**ADDENDUM NO. 2
TENDER NO. 64-24
HOWARD AVENUE & SOUTH CAMERON BOULEVARD INTERSECTION
IMPROVEMENTS**

June 21, 2024

This addendum amends and forms part of the Tender Documents. The bidder shall insert the addendum behind the cover page of the Tender Documents.

TITLE: SETTLEMENT MONITORING PLAN

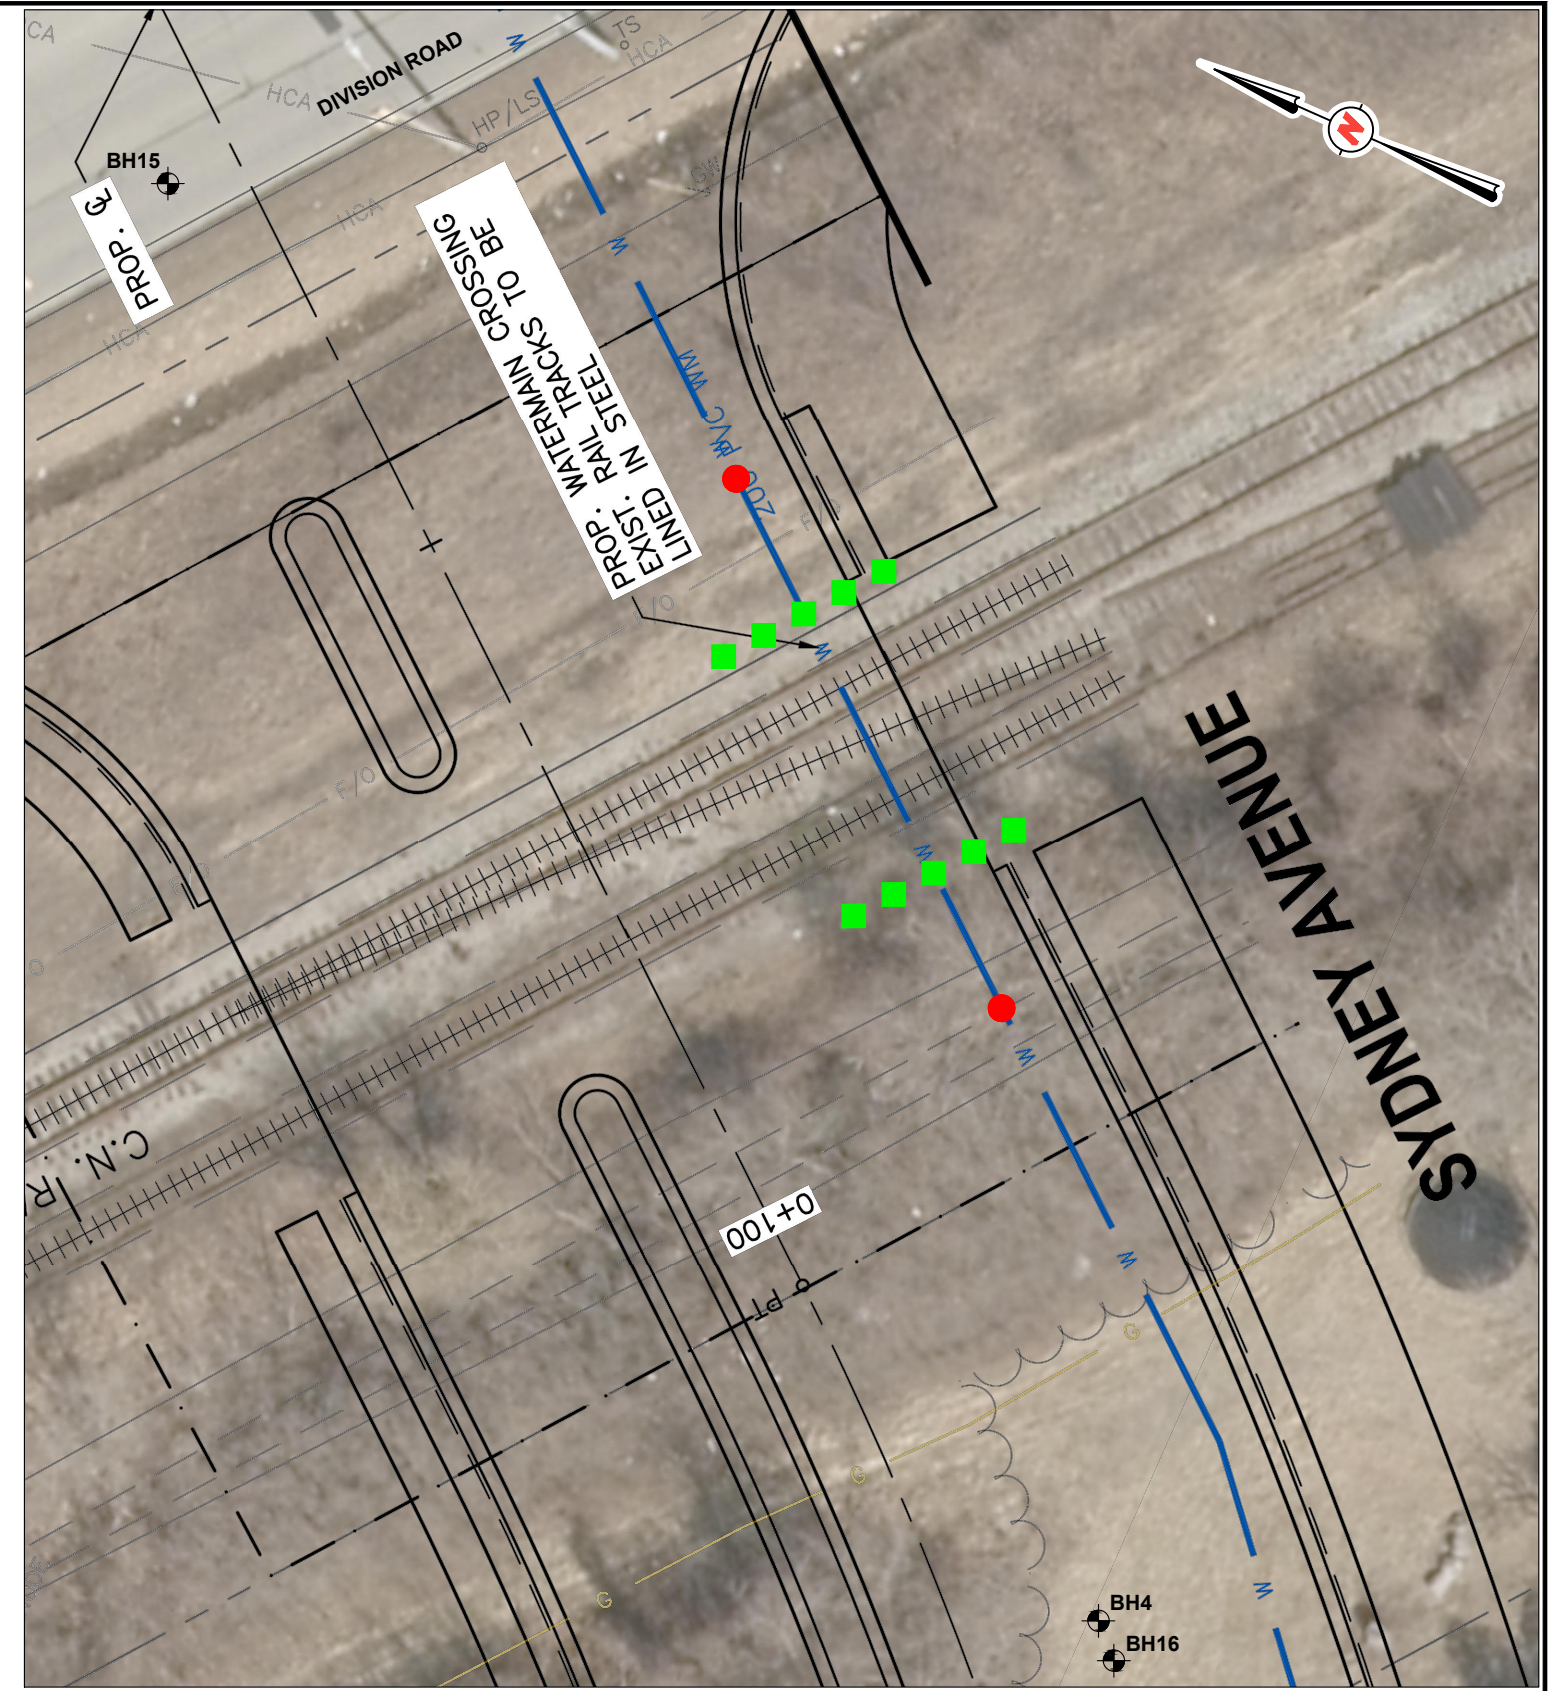
- Surface elevations have been added to borehole logs
- Discussion on soil behaviour related to the Jack and Bore operation has been added to section 5.13.
- Settlement monitoring alert levels (5.14.3) have been revised to align with CN Rail requirements.

The proposed monitoring locations are shown on Figure 3 and the details regarding the installations are provided below. An array of five monitoring points will be installed at a 2 m spacing above and centered on the casing alignment, on either side of the two active rail lines, including between them.

The remaining survey monitoring points will consist of hammer (or augured if hammering is not possible) driven 10 mm diameter steel rods a minimum 900 mm in length. The details of the installation method can be found on Figure 3, attached. These points will be replaced by in-ground monitoring points if driving them as deep as 900 mm becomes impractical.

A minimum of two in-ground settlement monitoring points will be installed directly over the centerline of the proposed watermain on the north and south sides of the railway corridor about 1.2 m below ground surface. The in-ground settlement monitoring points will be installed in pre-augured holes and consist of continuous steel rods cement grouted for a minimum of 200 mm length at the tip of the installation, as shown on Figure 3, attached.
